Technical Service Information

FORD 4R100 "NON-PTO" AND "PTO" HYDRAULIC DIFFERENCES

CHANGE: Beginning at the start of production for 1999 models, Ford Motor Company made available a "Power Take Off" option for some F250, F350, F450 and F550 Super Duty Trucks, equipped with 5.4L, 6.8L and 7.3L engines.

Figure 1

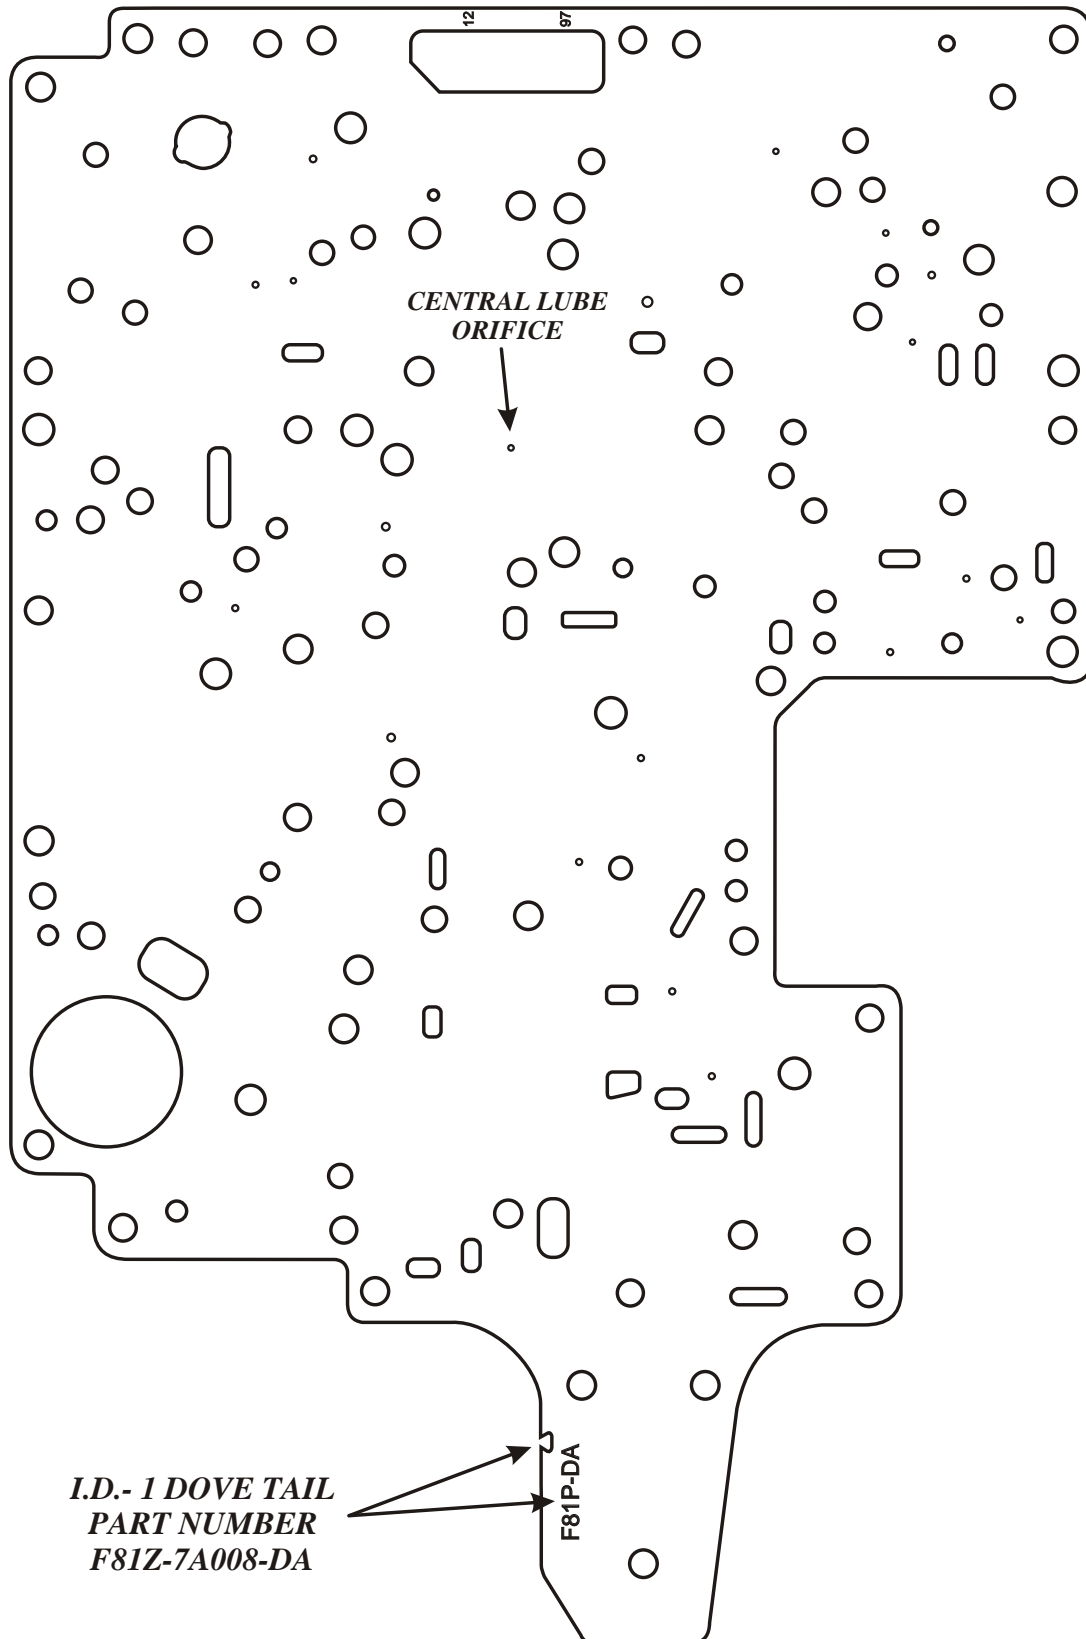
- (1) **TRANSMISSION CASE:** The transmission case was changed to accommodate the "PTO" window, as shown in ATSG Bulletin No. 98-56. All 4R100 Cases, "NON-PTO" and "PTO," also had a "Dam" added to separate "Rear Lube" and to incorporate "Central Lube" as shown in Figure 1.

Figure 3

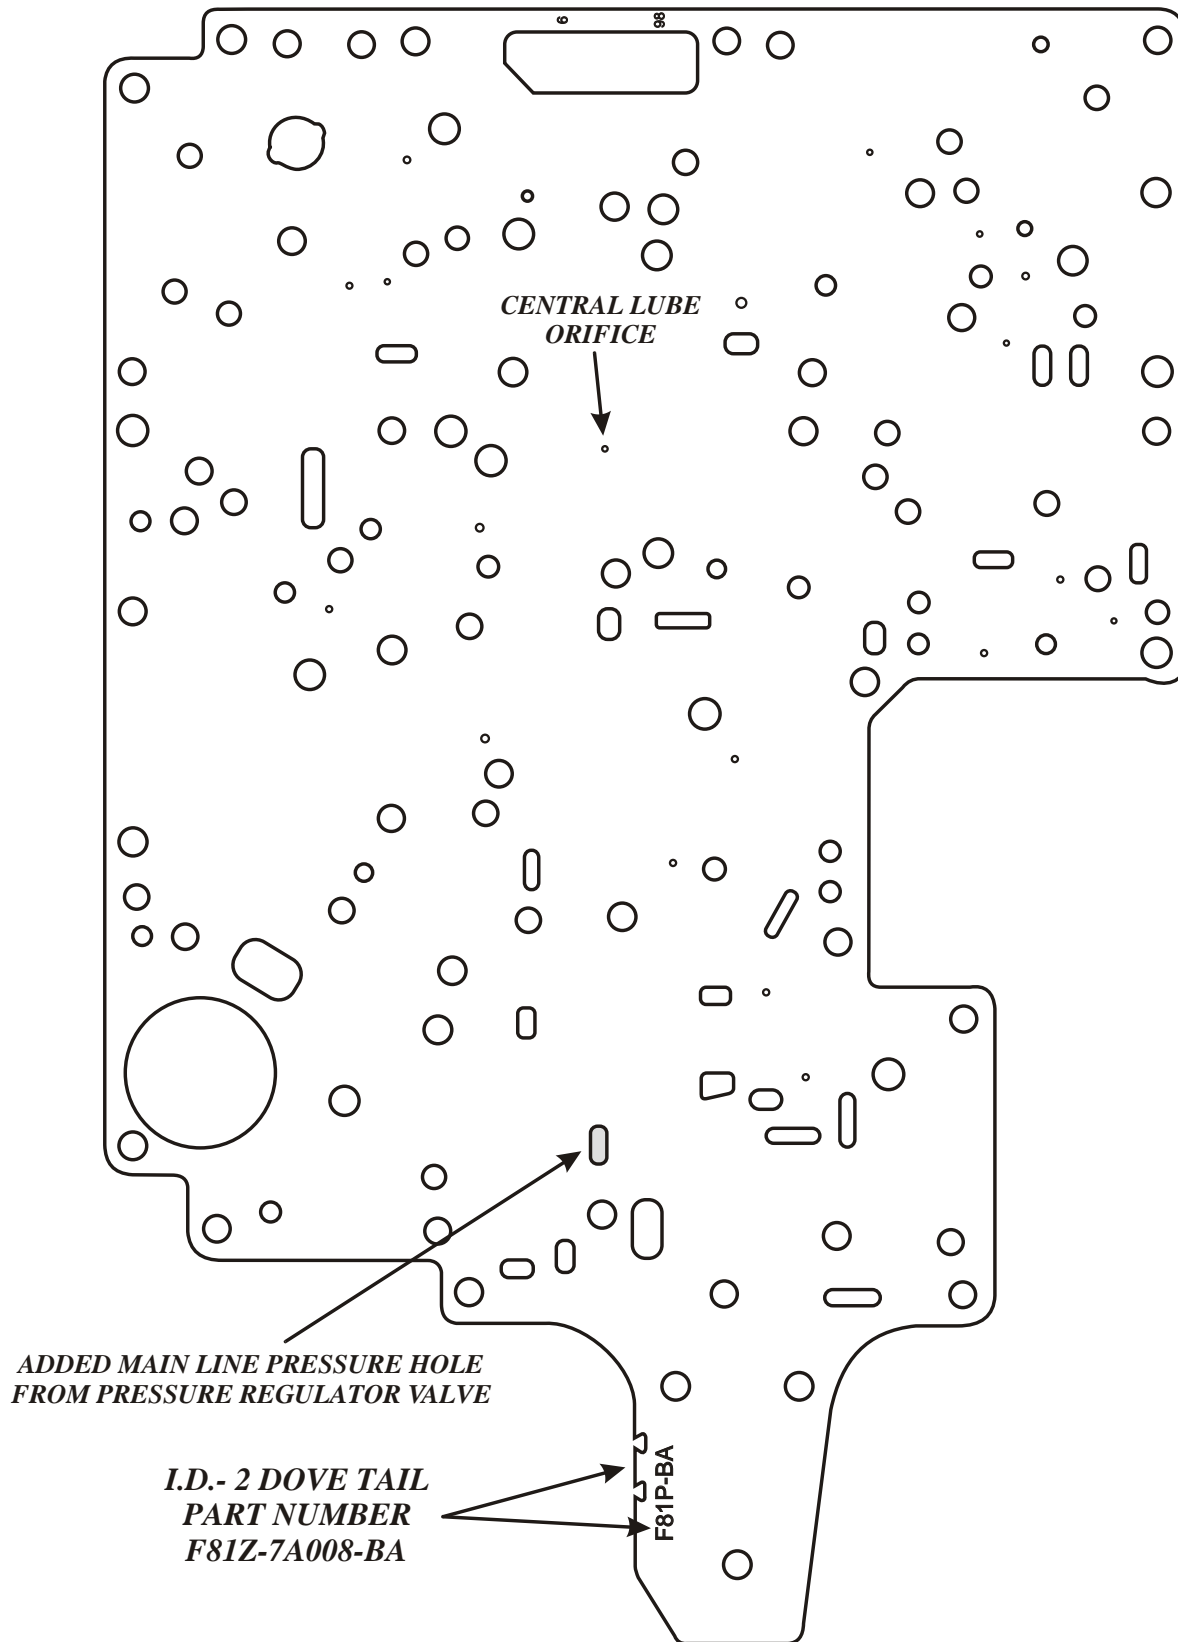
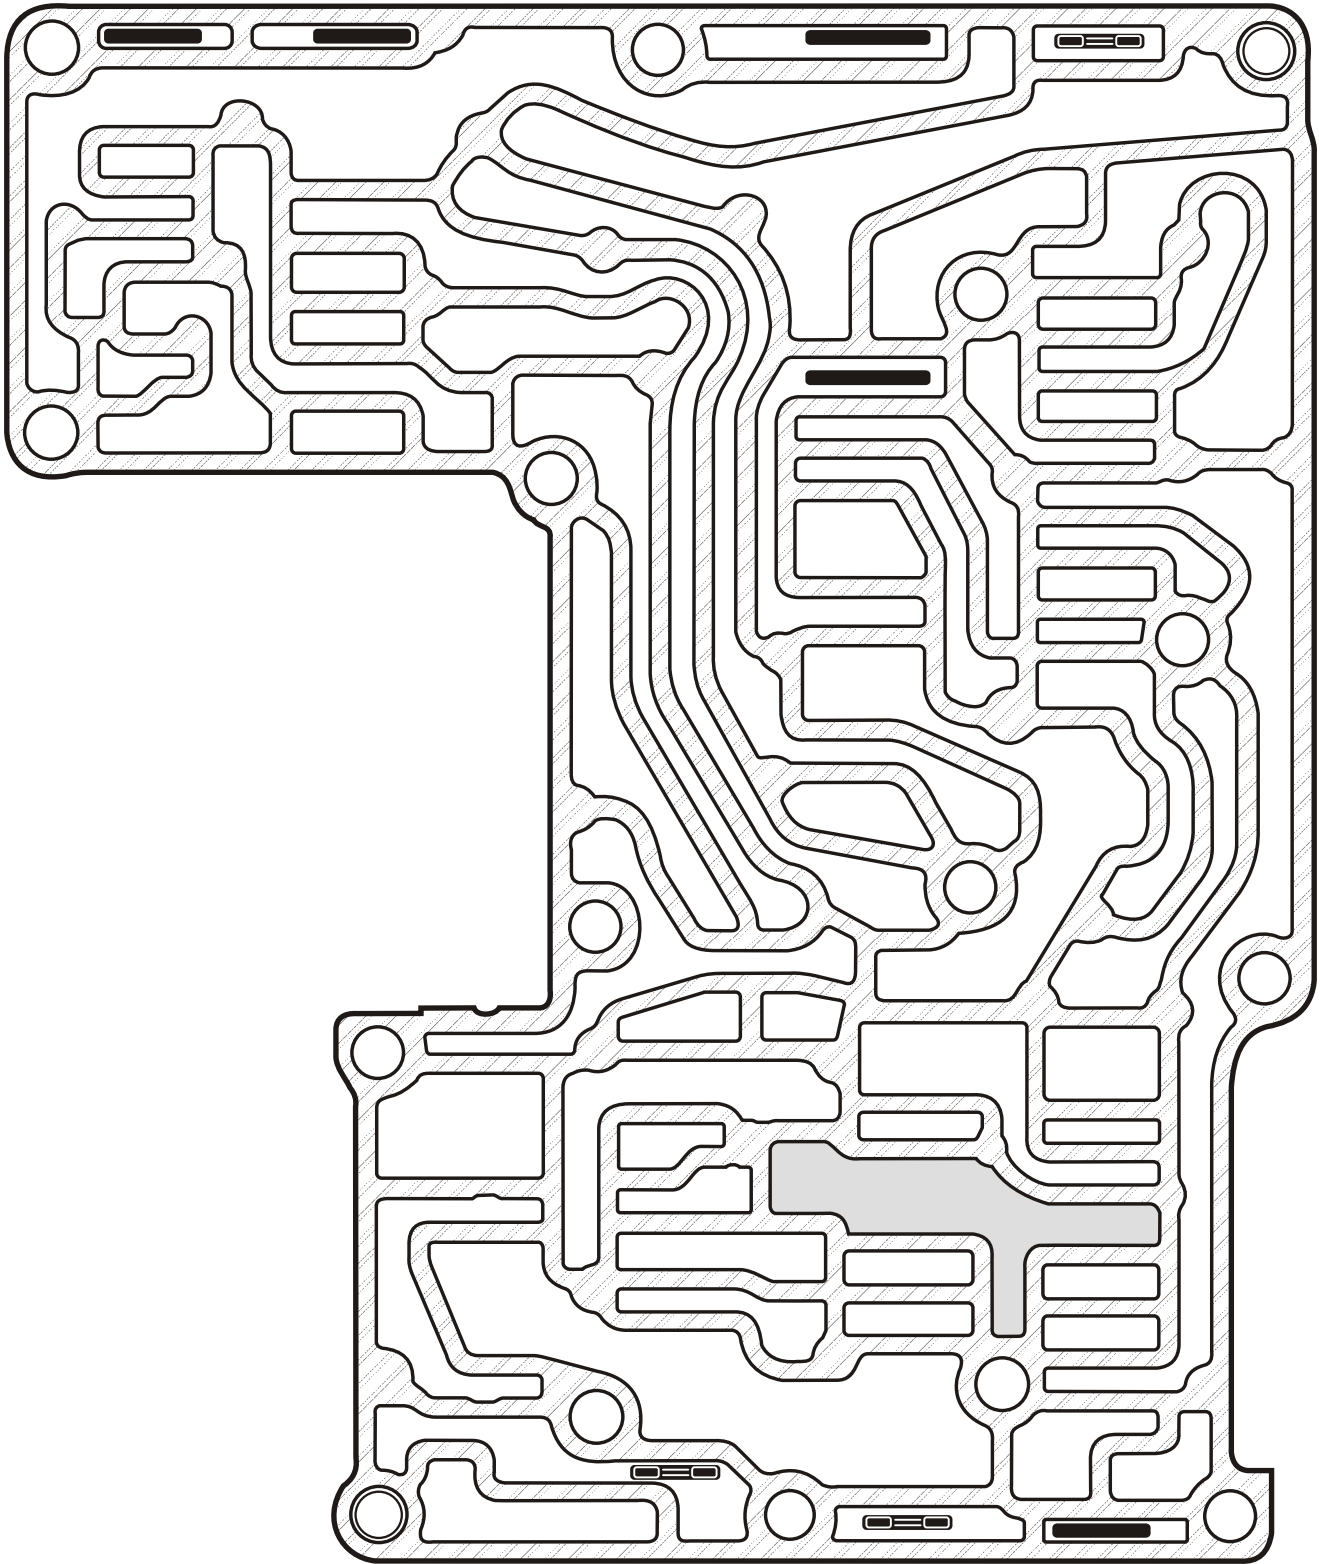
- (2) **VALVE BODY TO CASE SPACER PLATE:** The Valve Body to Case Spacer plate on the "PTO" versions had a hole added to supply the 3-4 Shift Valve with Line Pressure, as shown in Figure 3. A hole was also added to the Spacer Plate on "NON-PTO" and "PTO" versions to connect "Solenoid Regulator Valve" oil to supply "Central Lubrication." Refer to Figures 2 and 3 for identification of "NON-PTO" and "PTO" Valve Body To Case Spacer Plates.

Figure 5

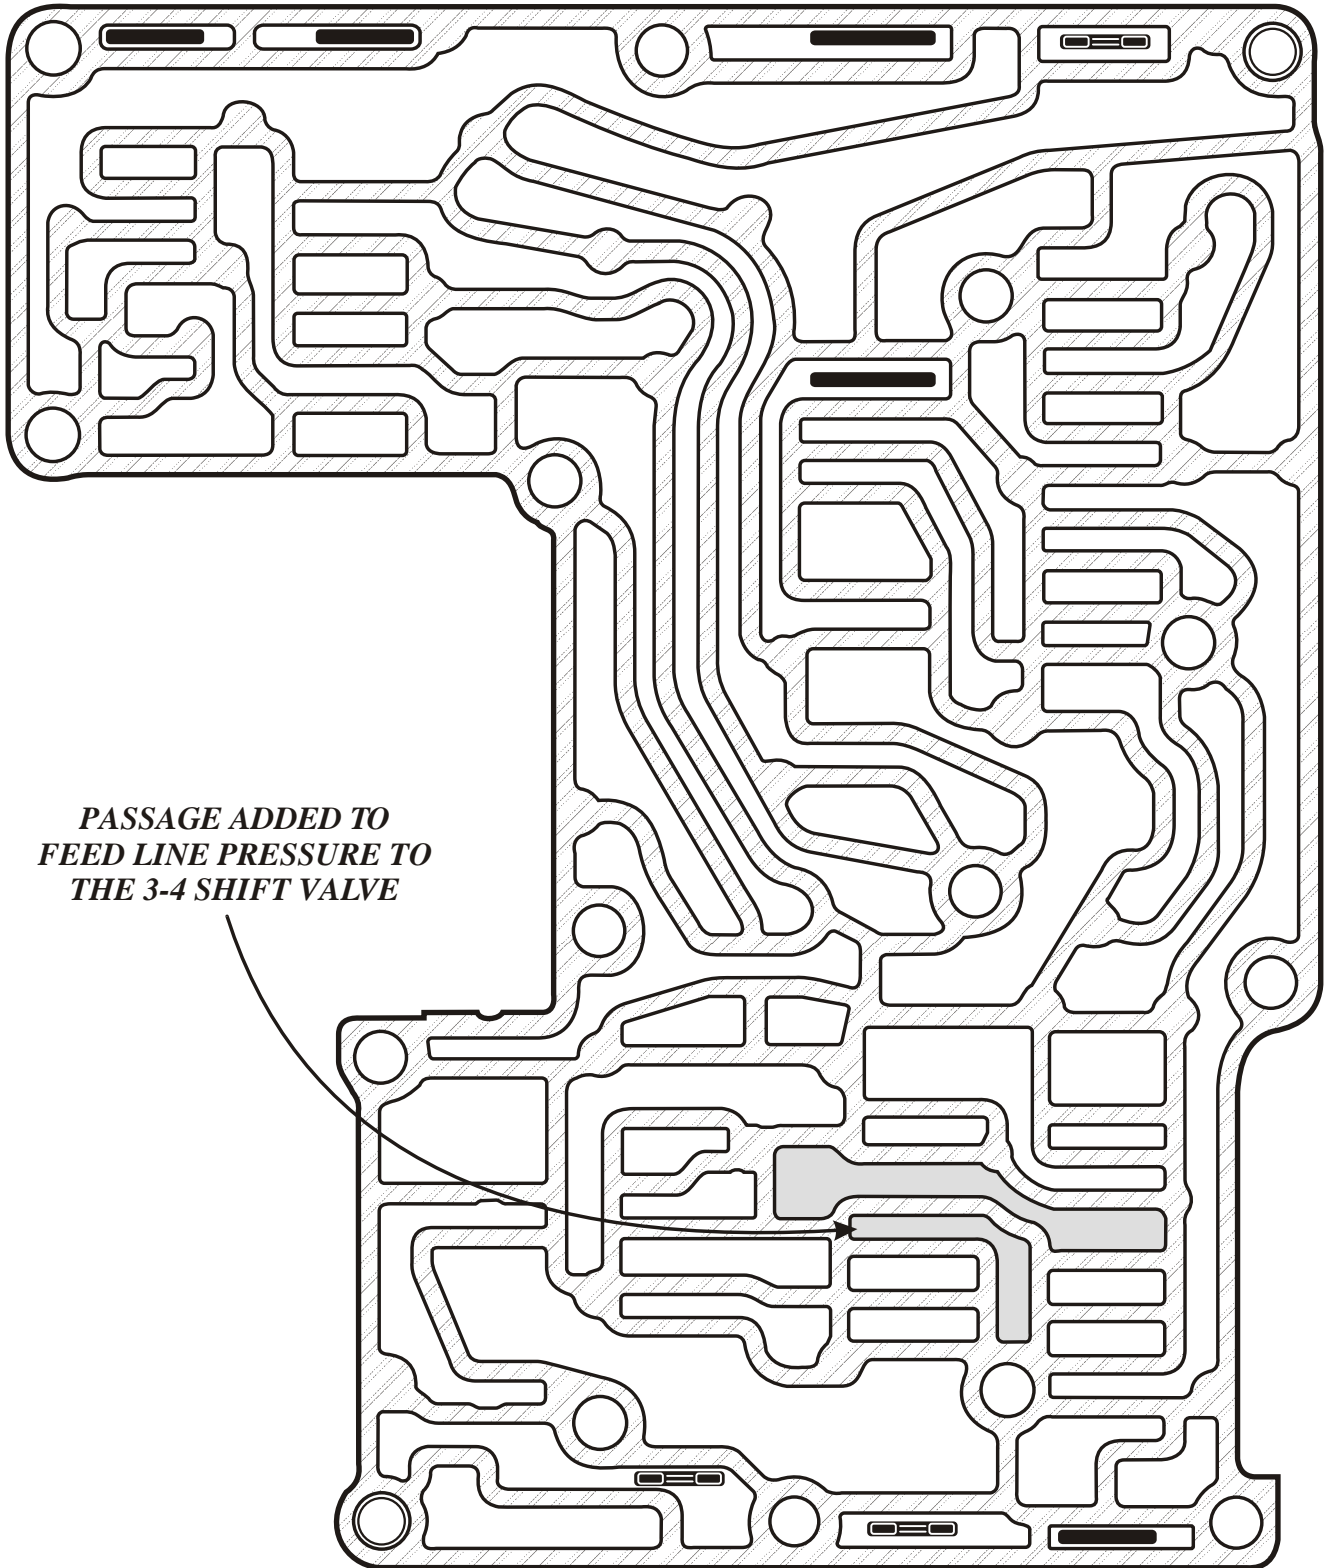
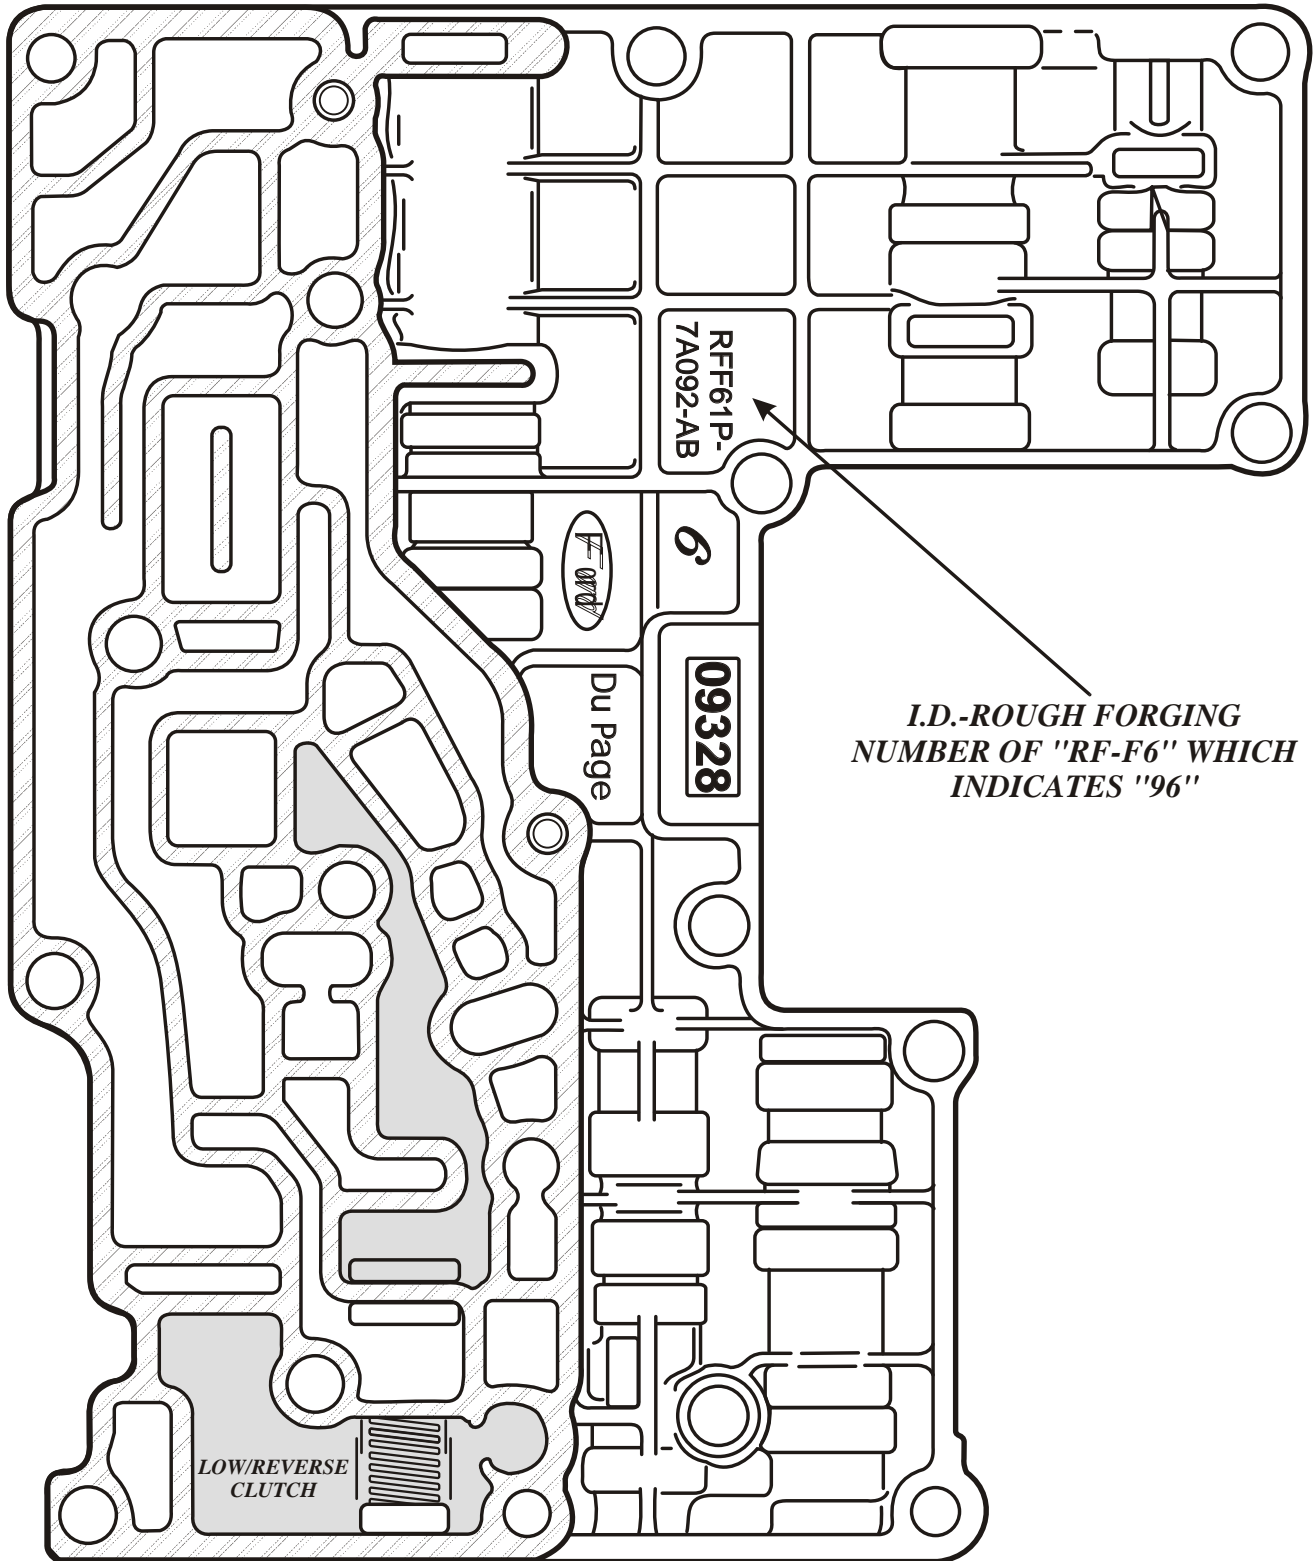
- (3) **MAIN VALVE BODY:** A passage was added on the "Upper Side" of the Main Valve Body on "PTO" versions, as shown in Figure 5, to supply Line Pressure to the 3-4 Shift Valve. A passage was also added, on the "Lower Side" of the Main Valve Body, to connect the 3-4 Shift Valve (Coast Clutch Circuit) to an exhaust as shown in Figure 7. The spring side of the 3-4 Shift Valve was also separated from the Low/Reverse circuit as shown in Figure 7. Refer to Figures 4-7 for identification of "NON-PTO" and "PTO" Main Valvebody's.

*PASSAGE ADDED TO
FEED LINE PRESSURE TO
THE 3-4 SHIFT VALVE*
